ADDENDUM #2 TO
MONTANA DEPARTMENT OF TRANSPORTATION
INVITATION FOR BID
#HWY-309727-RP

The purpose of this addendum is for the 2nd Approved Equals Request for Exceptions for the 35-Passenger Over the Road Mid-Size Coach Vehicles.

REQUEST FOR EXCEPTIONS/APPROVED EQUALS FORM

TYPE OF VEHICLE/EQUIPMENT: 35 Passenger Midsized Coach

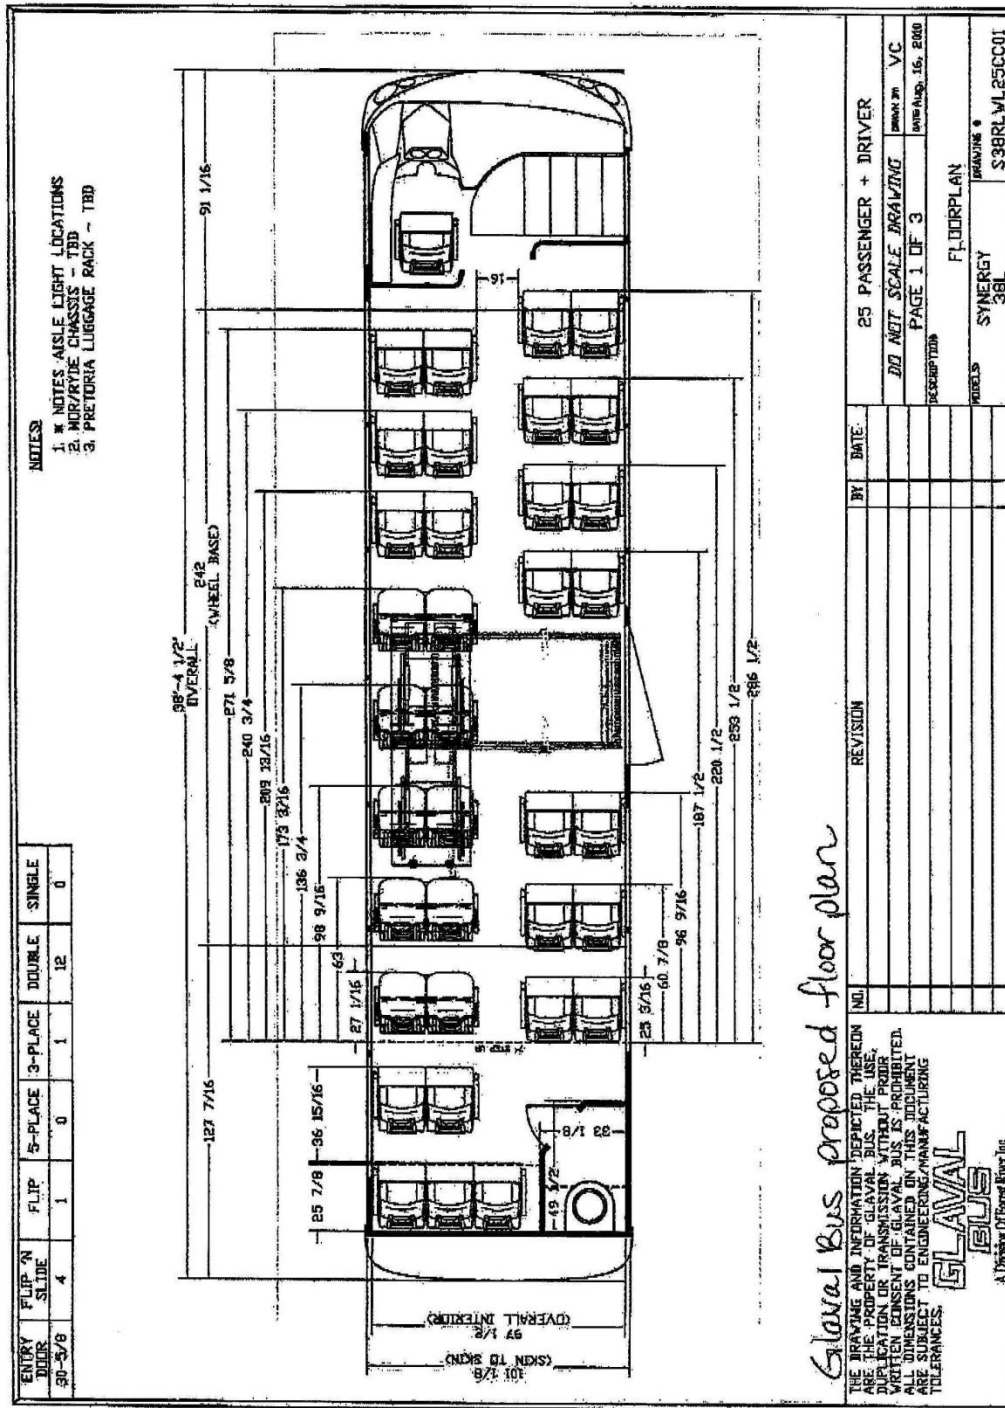
#	Spec #	Specification Ref.	Request for exception or approved equal	MDT Response	MDT Comment
1	5.1.3	Wheelbase	Request to accept a wheelbase of 242" as shown in floor plan.	Yes	
2	5.1.4	Frame	Request to accept a Freightliner XBR frame with a stacked rail and a 127 ½" rear overhang as shown in attached floor plan. Overhang is still in the 1/3-2/3 ratio.	Yes	
3	5.1.6	Ceiling Height	Exception that the last 2 rows of bus have a 73" interior ceiling due to a 7" step-up.	Yes	
4	5.2.1	Engine	Request to accept a 275 HP Cummins Diesel Engine. Request to accept the bus without a retarder control and control switch as there is not enough physical room in the driveshaft area.	Yes
